173-175 FRIAR STREET, READING

FIRE ENGINEERING REVIEW

ES1652/zf/01nor
19th October 2020

Figure 1 – Stair 01 arrangement at Levels 01 to 04

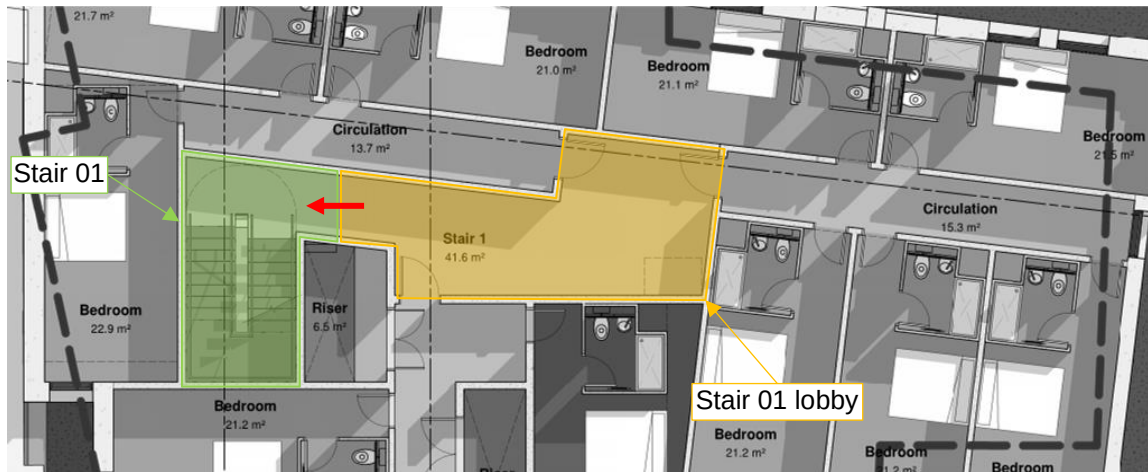
The ADB recommends that occupants should not need to escape through one stair to reach another stair; however, it is acceptable for occupants to pass through one stair lobby to reach another stair.

As drawn, occupants within the northern bedrooms will need to escape via Stair 01 to reach Stair 02 at Levels 01 to 05; and, occupants within the back-of-house areas at Level -01 will need to escape via Stair 01 to reach Stair 03. To resolve this, Stair 01 should be provided with a protected lobby as shown indicatively in Figures 1-3 below.

Figure 3 – Stair 01 arrangement at Level-01

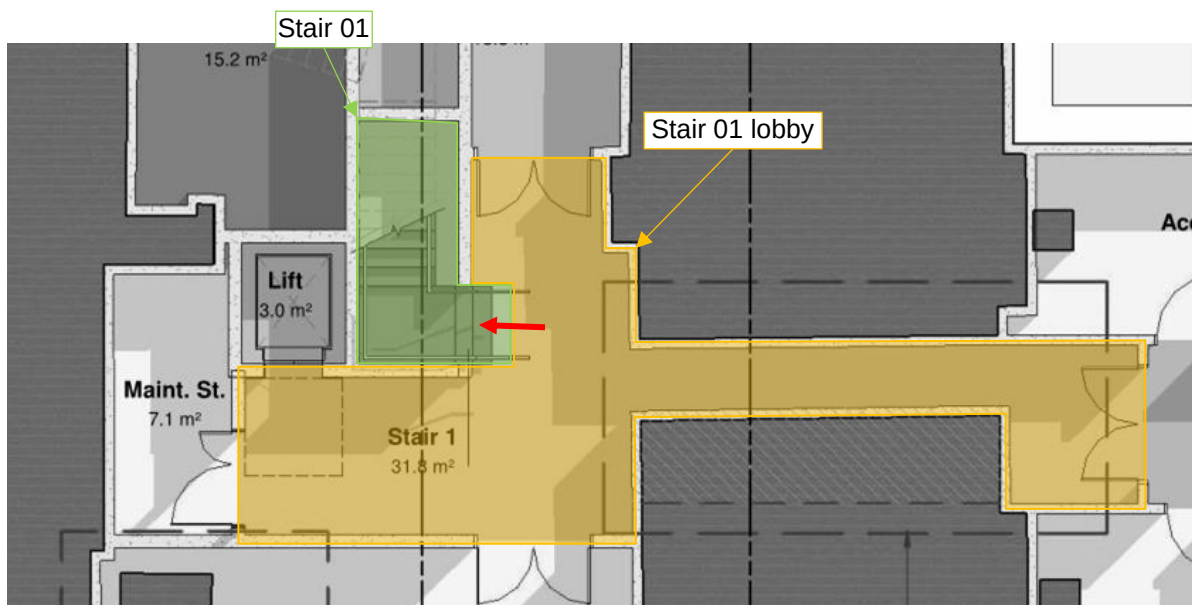
If any of the plant rooms at Level -01 accessed from the stair lobby are regarded as places of special fire hazard; the lobby should be provided with a minimum 0.4m² of permanent ventilation, or be protected by a mechanical smoke control system.

Figure 6 – Provision of smoke control cross-corridor doors to dead-ends at Levels 01-06

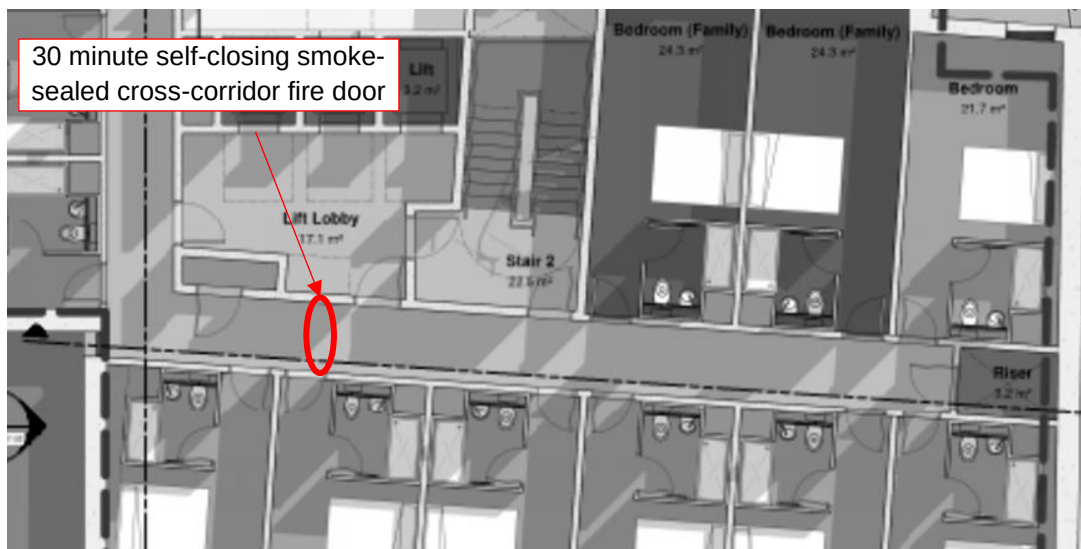
Every dead-end corridor exceeding 4.5m in length should be separated from any part of the corridor which provides escape in more than one direction or continues from one storey exit to another with 30 minute fire rated construction, including 30 minute smoke-sealed self-closing fire doors.

Cross-corridor doors should be provided within the dead-end corridors past the lobby door to Stair 02 at Levels 01-06 as shown indicatively in Figure 6 below.

Figure 7 – Fire fighting shaft arrangement at Level 00

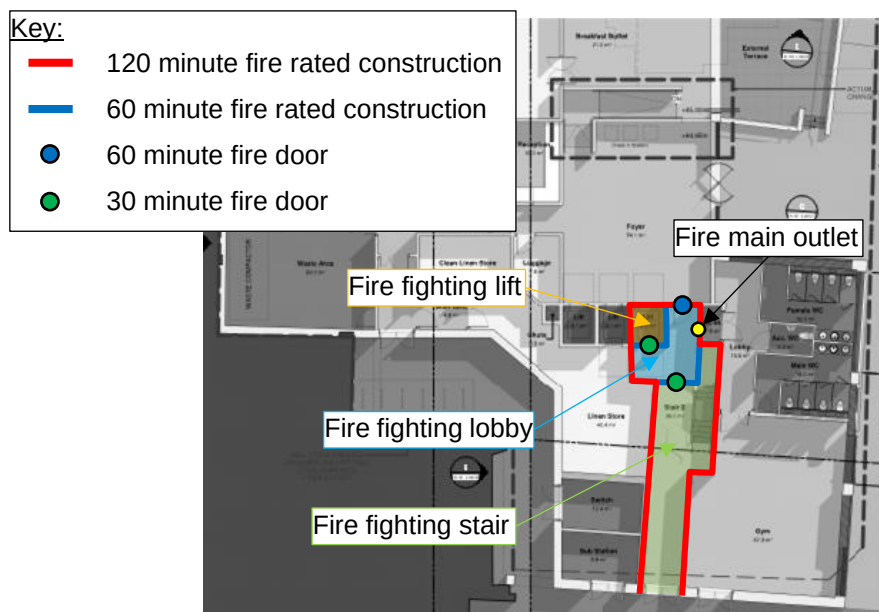
The ADB recommends that at least two fire fighting shafts should be provided where a storey area is greater than 900m². Therefore, as the area of Levels 00 to 04 exceeds 900m², two fire fighting shafts would be required within the hotel building to meet code guidance. This would require either Stair 01 or Stair 03 to be designed as a fire fighting shaft with the provisions outlined above, with access to the fire fighting shaft available from every storey.

However, it should be possible for JGA to develop a fire engineering solution to support only one fire fighting shaft based on the provision of sprinklers throughout the building; hose coverage achieved within 60m of the dry fire main within the fire fighting shaft at all upper storeys and each storey subdivided by compartment walls so that the area of each compartment does not exceed 900m². This is shown indicatively in Figure 7 for Level 00.

Figure 8 – Protection to the external walls at Level 00 to address external fire spread

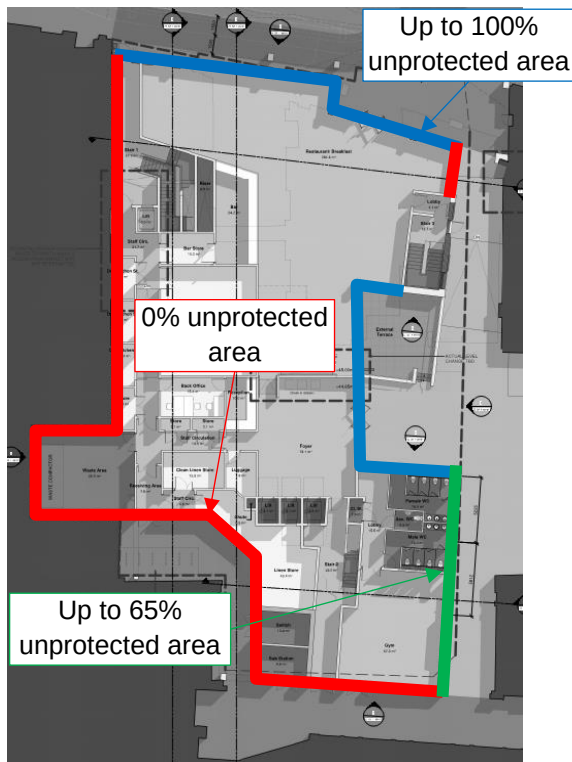
Some of the external façades of the hotel building should be fire protected to address external fire spread, as shown indicatively in Figures 8-14 below. The boundary distances have been measured as follows:

The boundary distances should be confirmed by the architect and discussed and agreed with the Approved Inspector. Where protection to the external walls is required, this should achieve at least 60 minutes fire resistance. The allowable percentage of unprotected areas would change if the boundary distances are altered or sprinklers are not provided throughout the hotel building.
